Volume 1

TURBO DIESEL Buyer's Guide

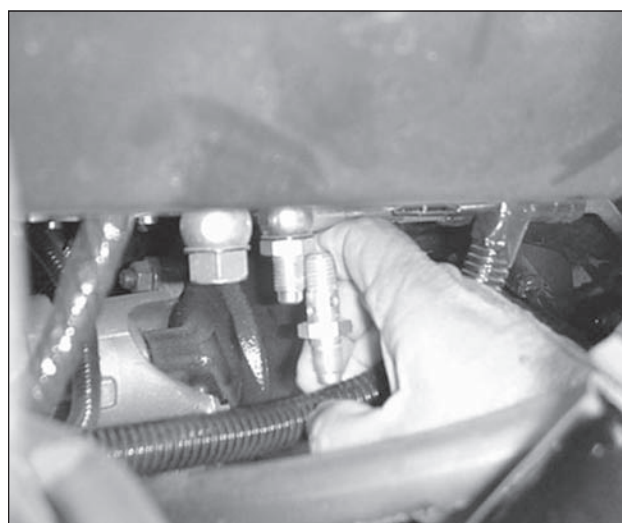
In order to install a gauge, the '98 and '99 24-valve engines have a filter head with easily accessible 1/8 NPT fittings. On the 2000 and up trucks the service design team at Cummins was mindful of the need to test the fuel transfer pump's delivery pressure. Thus, your truck is equipped with a "banjo adapter with a Schrader valve assembly." Say what? For clarification let's look at a photo and a description.
